Before the New Plymouth District Council

In the matter of Proposed Private Plan Change 48 to the New Plymouth District Plan requested by Oākura Farm Park Limited for the proposed rezoning of land at Wairau Road, Oākura

Statement of Evidence of Matthew Douglas Peacock

(Land Development & Subdivision Infrastructure Engineering)

STORMWATER CALCULATION - 10% AEP WAIRAU ESTATE - OAKURA

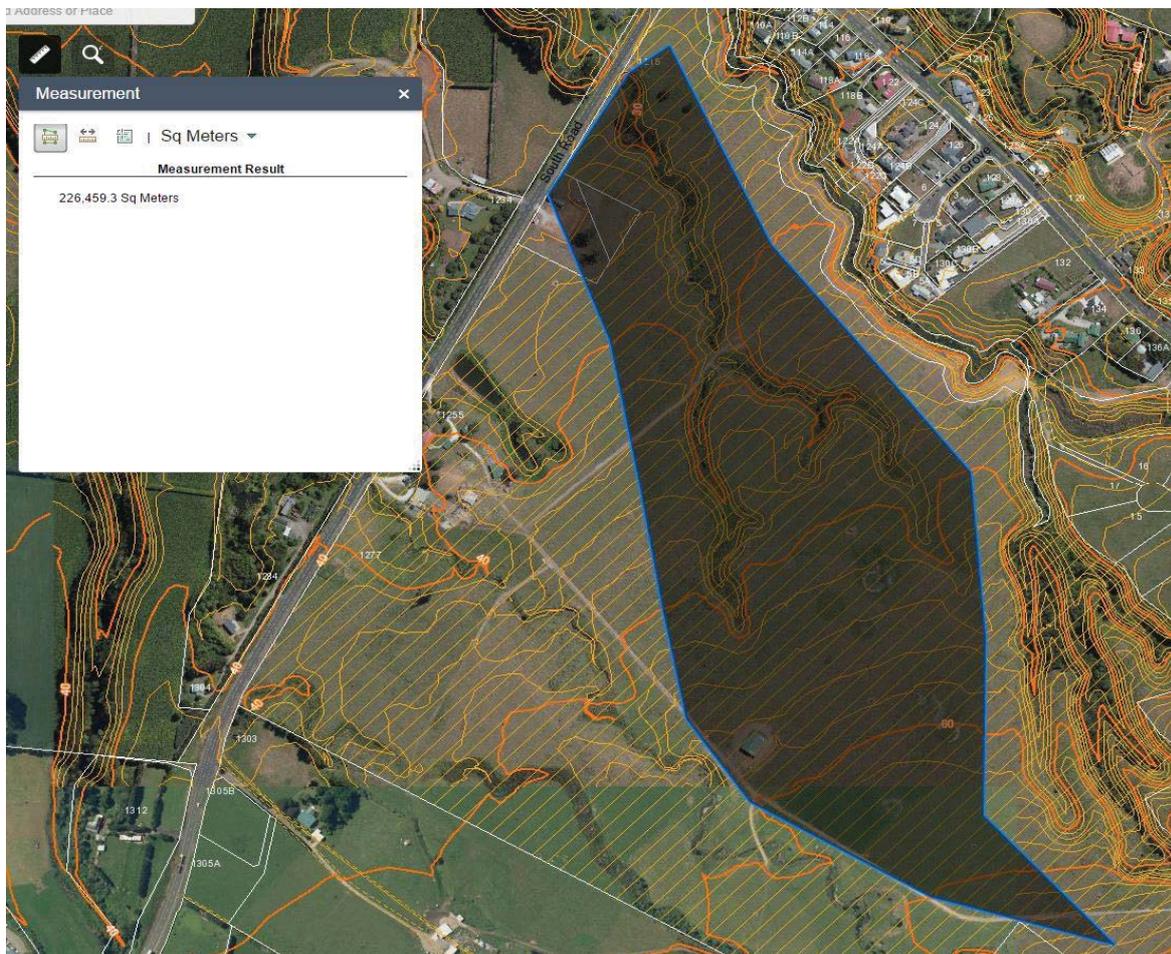
- 8.6 AFSE report paragraph 23 indicates detention ponds have been designed for 20% AEP (1 in 5 year storm) for 22.6Ha of developed land area to achieve hydraulic neutrality (ie no change from the current undeveloped land stormwater runoff).

- 8.7 Detention Ponds are a primary source of stormwater control so no secondary flow path is available, and stormwater design should be completed for a 1% AEP (1 in 100 year storm). The 100 year storm information has been provided by Red Jacket in its PPC48 application report for stormwater, and the total required storage calculation for detention Ponds shows 5021m³ is required, not the 2880m³ stated in paragraph 23.

- 8.9 Stormwater design in the Red Jacket PPC48 application report only accounts for 23ha of the proposed 58ha development, see Appendix I. Considering the acknowledged historical flooding issues downstream in Shearer Reserve area, where the council owned waste water pump station is located, the remaining 35ha of stormwater catchment area should be accounted for. If this stormwater is left to flow uncontrolled into catchment streams it may have negative downstream effects, in particular at the Shearer Reserve area.

PLANNING TITLE
**MAIN
PUMP STATION
SITE LAYOUT PLAN**

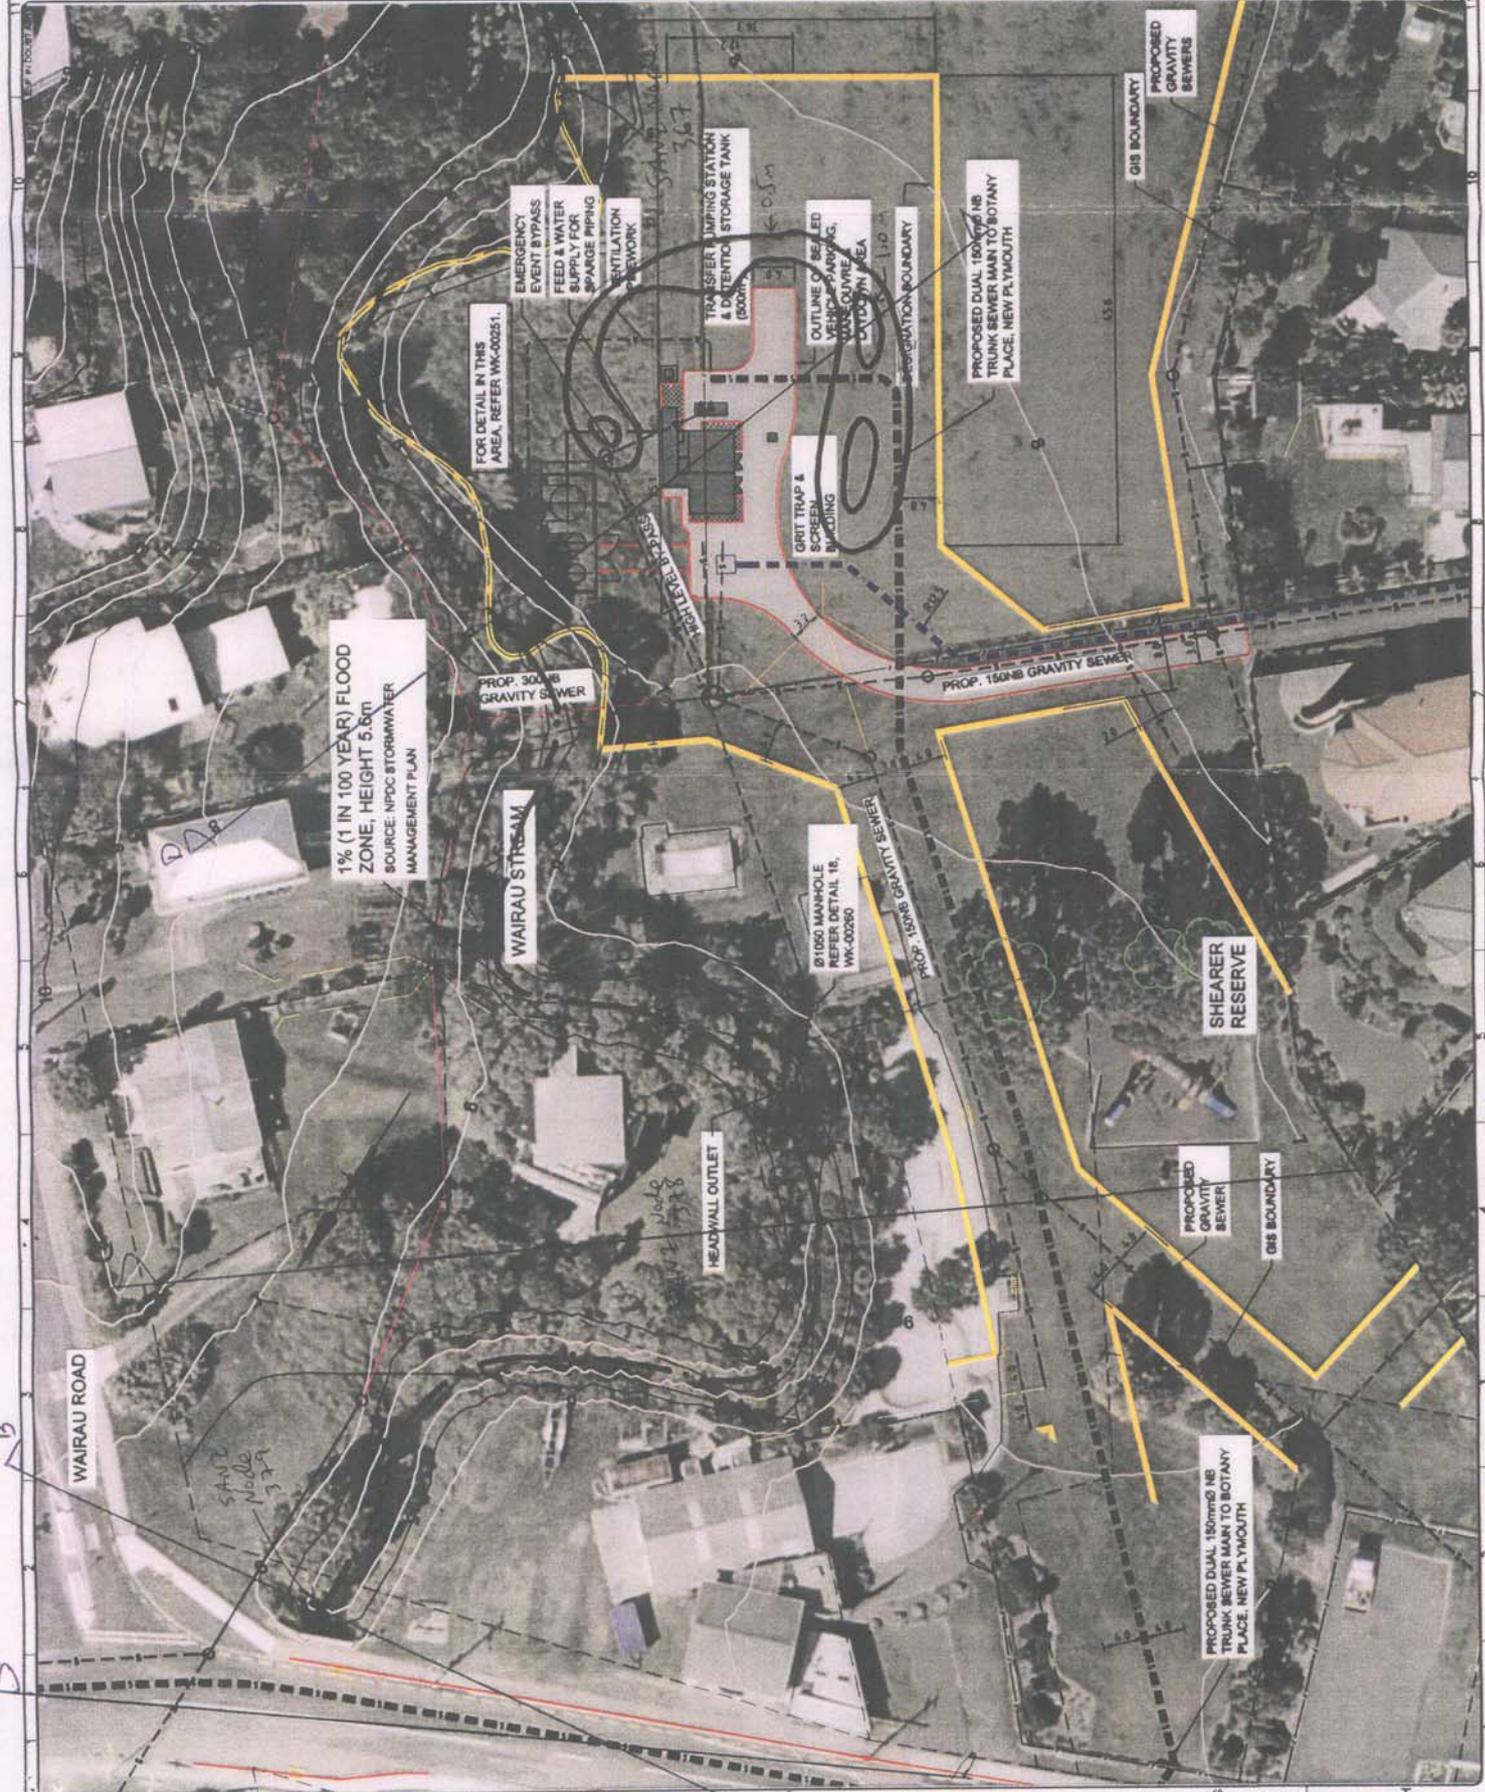
The SWMP ponding level (5.60m) was also shown on the pre-tender issue drawings for the pump station (WK-00250) implying that this is the height of the flood water at the pump station location. This is unlikely as the pump station location is 150 m upstream (along channel centerline) of the Tasman Parade Culvert and the bed level of the stream (from contour levels) at this point is 5.0m. We therefore concluded that this is unlikely to be the true flood level at the pump station location.

DRAWING NO. WK-00259
 SHEET 06 OF 06

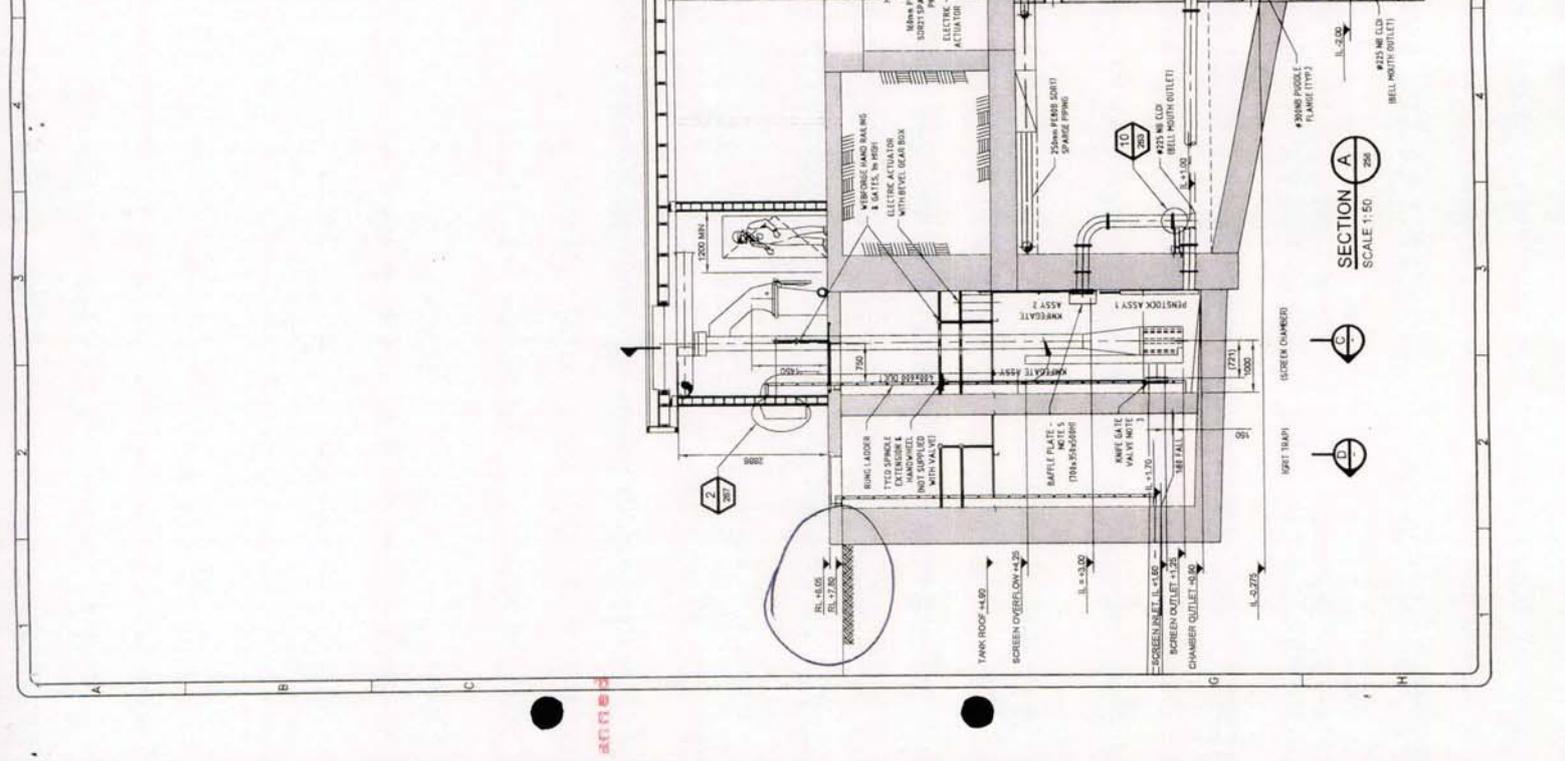
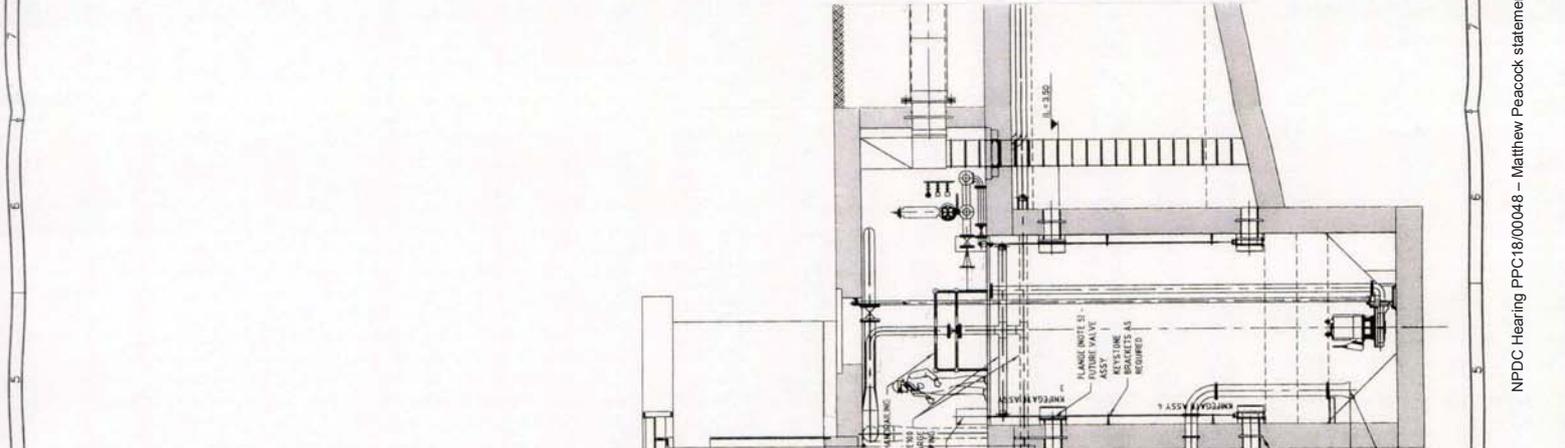
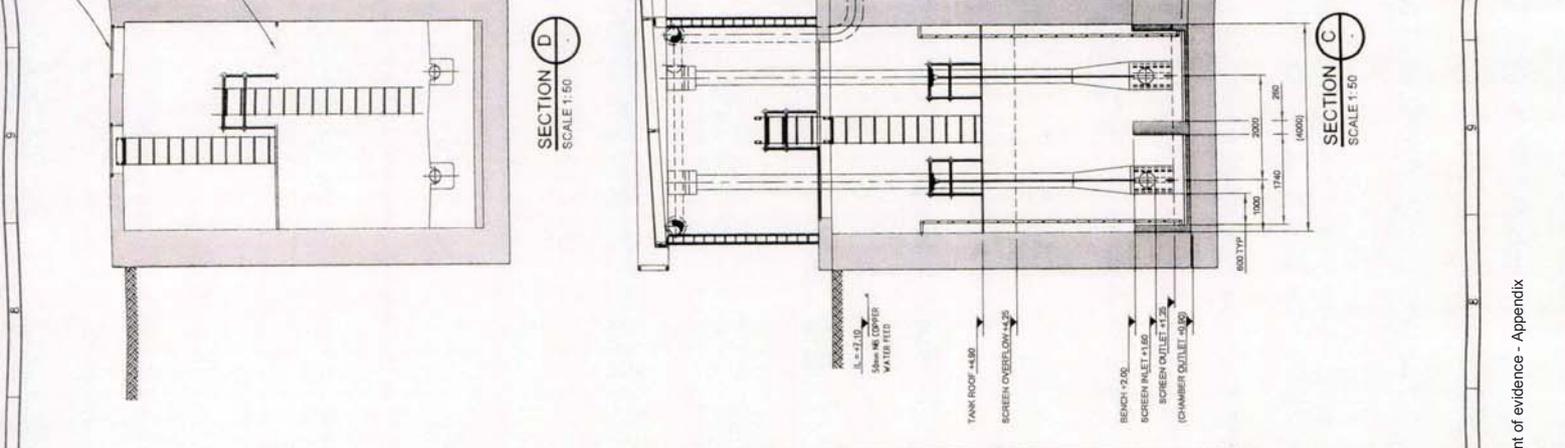
On the pre-tender issue drawings (refer to attached drawing WK-00259), ground level at the proposed pump station is 7.8m; the finished level for the slab over the pump station wet well is indicated to be flush with ground level, i.e. it is assumed this will have a finished level of 7.8m; and the specified finished level of the slab over the inlet screens is 8.05m.

Therefore based upon the flood levels estimated in this review there is no free board between the flood ponding level and the finished level of parts of the pump station. Given the level of accuracy of some of the inputs into this review (i.e. the cross-section levels where obtained from MapTV contours) this review indicates that it is possible that the pump station will be flooded during a 1% AEP event. If greater certainty is required regarding the flooding levels, a more detailed assessment will be necessary.

Photo 4. Wairau Stream Tributary gully at the point where the road into the proposed WES subdivision will cross. The new road will be 20 meters wide, maximum slope of 10% and will span approximately 80 meters between east and west banks.

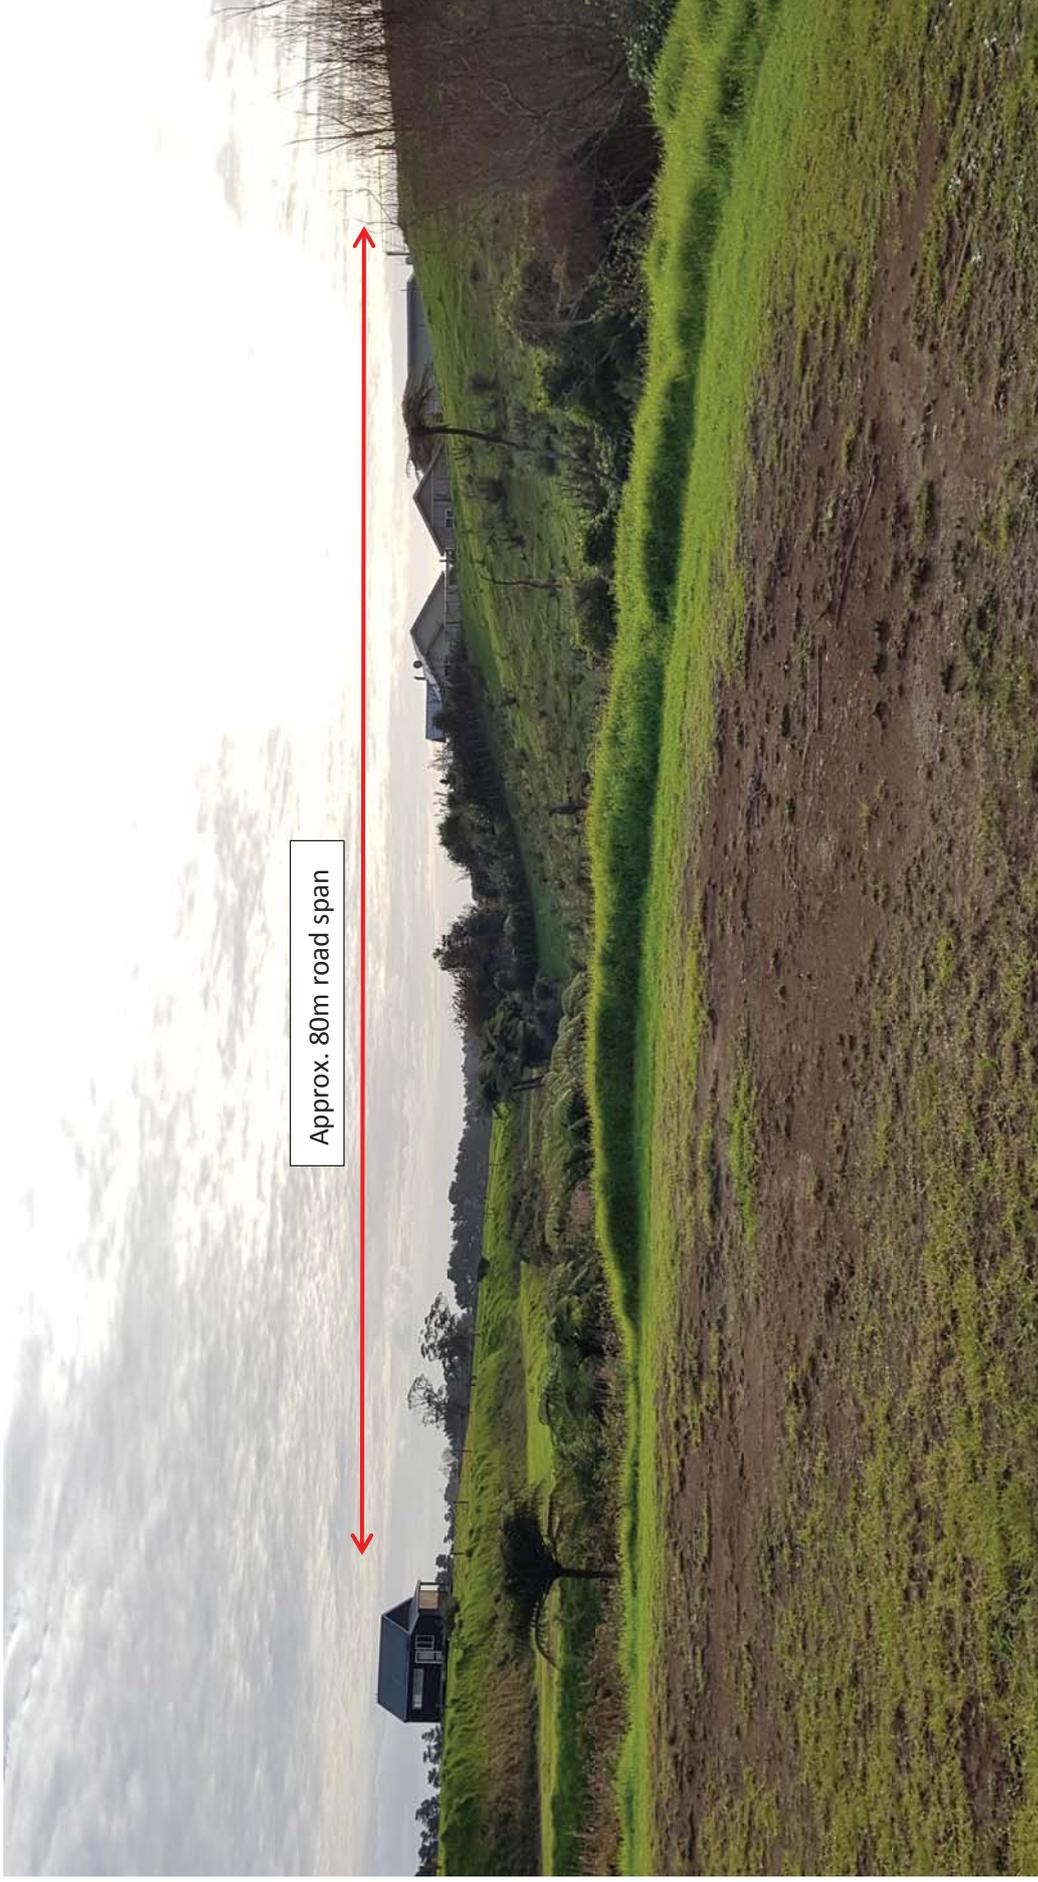
- 10.3 Access from any point along upper and lower Wairau Road across the Wairau Stream tributary is a significant undertaking involving earthworks, culverts and the formation of a 20 meter wide road corridor, just to traverse the stream and reach the development area. See photos **Appendix II**.
